# Thomas Green Street

## UPDATES TO STREET LAYOUT

**DRAFT** - conceptual plan for discussion only -  
 based on Thomas Green Street Concept Plan

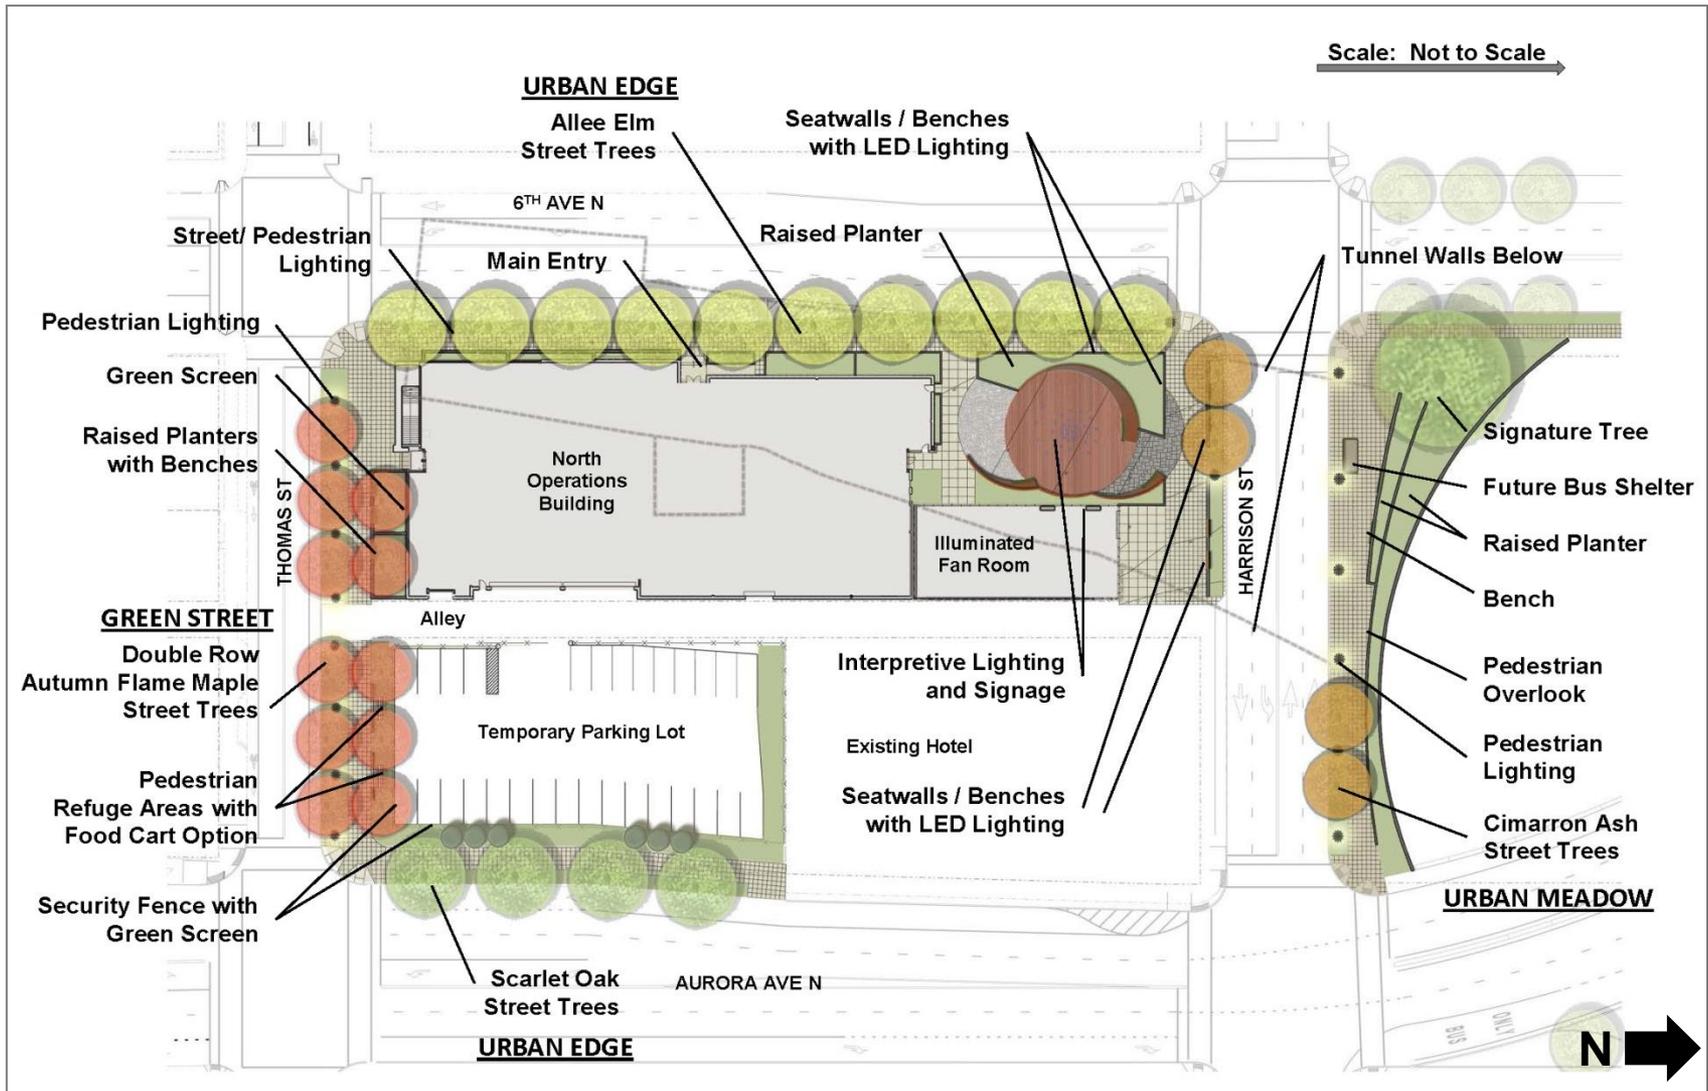
- Removed center left-turn lane
- Added two 5' bike lanes
- Widened north sidewalk from 18' to 22'
- Created double allée of Maple trees utilizing 10 feet of building property
